Release Notes

MLTG-CN LR

Version: 1.4.0-00123-7e047ba
Enhanced from version 1.3.2-00561-e8e952a

2. Radio Configuration Page

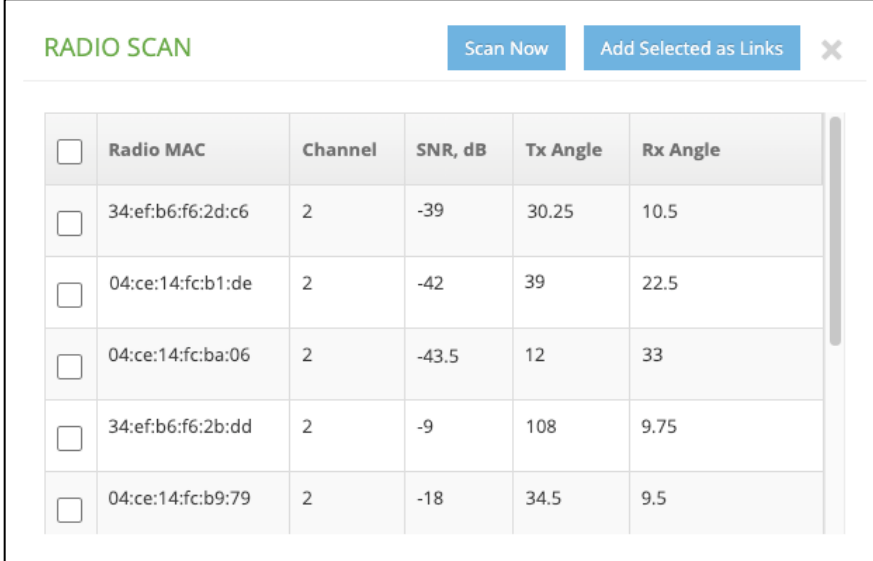
Link Configuration page is re-designed to be Radio Configuration page. It is only available for Base Station mode.

Channel and links can be configured in the Radio Configuration page. Based on the capability, up to 15 links can be configured for MLTG-CN, and only 1 link can be configured for MLTG-CN LR.

An Enable/Disable switch is added to each link. It allows administrator to disable specific links temporarily and add it back easily.
